HISTORIC AND DESIGN REVIEW COMMISSION

HDRC CASE NO: 2018-149
ADDRESS: 200 HASKIN
LEGAL DESCRIPTION:
ZONING: NP-8
CITY COUNCIL DIST.: 10
APPLICANT: Marc Zak/Terra Design Group
OWNER: City of San Antonio
TYPE OF WORK: Park improvements
APPLICATION RECEIVED: March 30, 2018
60-DAY REVIEW: May 29, 2018

REQUEST:

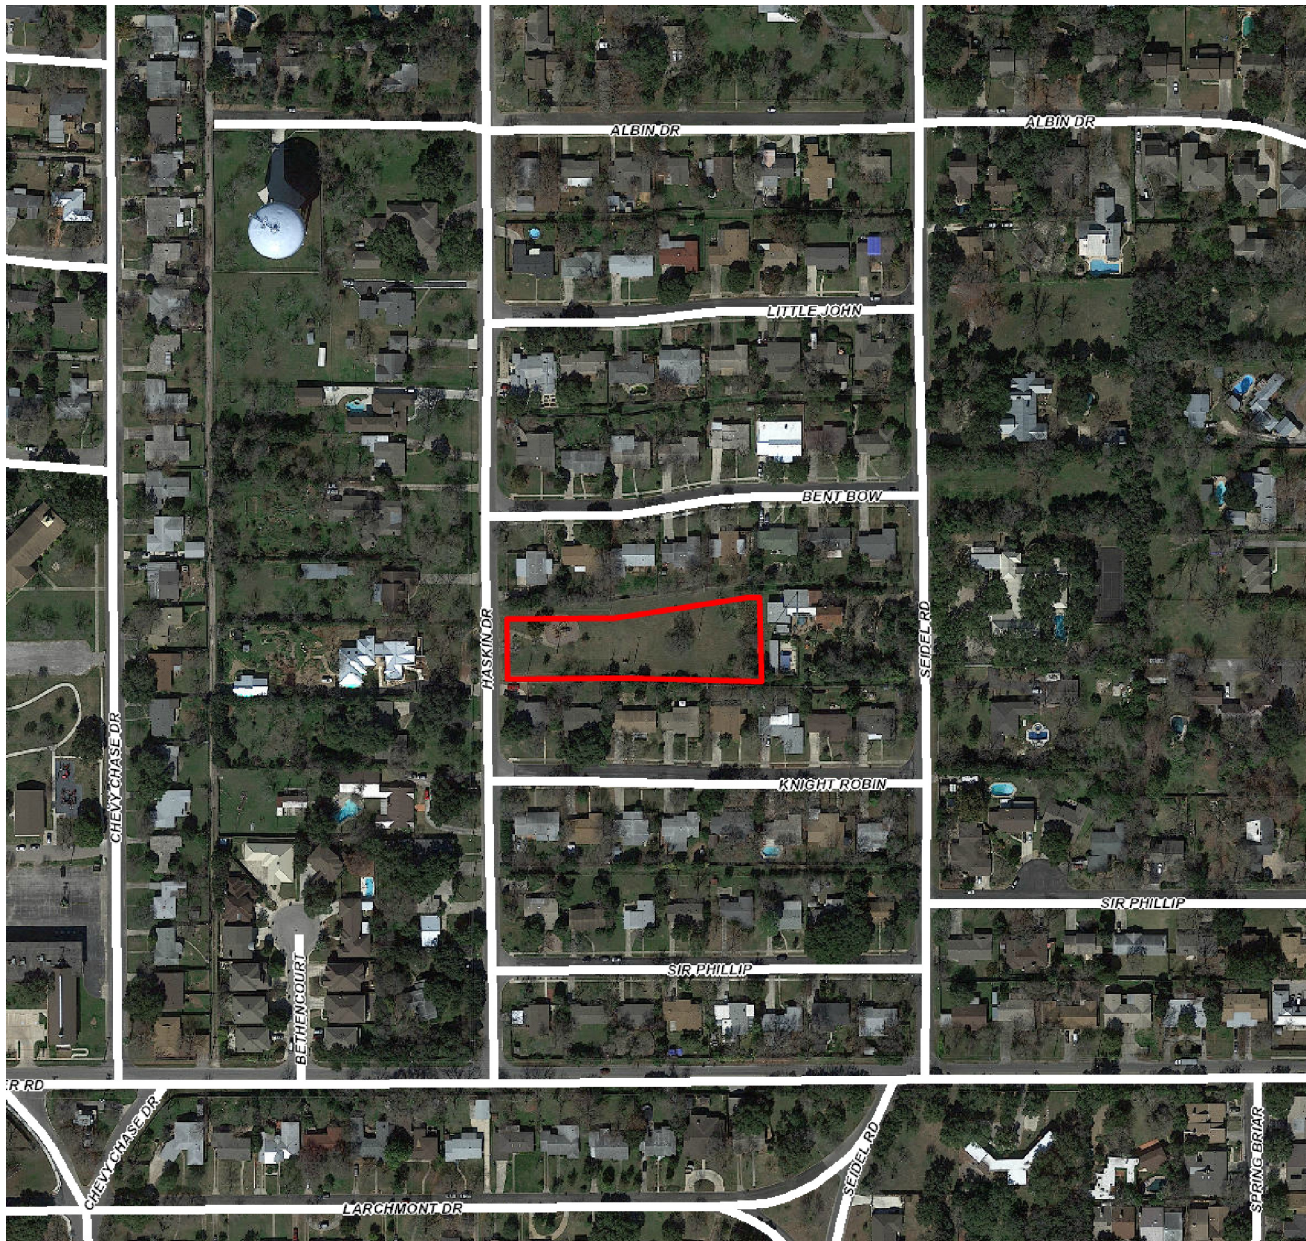
- a. The property located at 200 Haskin is the site of Haskin Park. The applicant is requesting approval for a series of park improvements, including parking modifications, landscaping and hardscaping, and re-grading.

- b. PARKING MODIFICATIONS – The applicant has proposed to install additional concrete pavement to the existing parking spaces accessed off Haskin. The parking improvements will allow for increased accessibility for park patrons. Staff finds the proposal appropriate.

- c. NEW TRAIL – The applicant has proposed to install a concrete loop trail. The trail will run the perimeter of the park with an inner loop located near the existing playscape. The trail will measure approximately 6’-0” in width and feature a series of bench landings for pedestrians. According to the UDC, paving surfaces should be durable and safe for pedestrians. Pedestrian circulation should feature a clear path-of-travel at least thirty-six inches wide. Seating should be durable, attractive, and comfortable, and provide for a variety of experiences for users. Staff finds the proposal consistent with the UDC.

- d. LANDSCAPING – The applicant has proposed several modifications to the existing landscape condition, including the removal of several existing trees, planting of new trees and shrubbery, installation of increased sod cover, and irrigation improvements. The new sod will provide a more consistent, continuous open park space within the proposed trail. The new trees will add additional canopy cover and the proposed shrubbery will add screening and depth to the entrance and parking off Haskin. According to the UDC, adding landscaping along sidewalks strengthens the visual quality of public streets. Staff finds the proposal appropriate.

- e. PLAY AREA IMPROVEMENTS – The applicant has proposed play area improvements to include re-grading and the relocation of an existing lighting pole from the center of the open green park space. Staff finds the improvements appropriate considering the rest of the scope of the project and consistent with the UDC.

Staff recommends approval as submitted based on findings a through e.
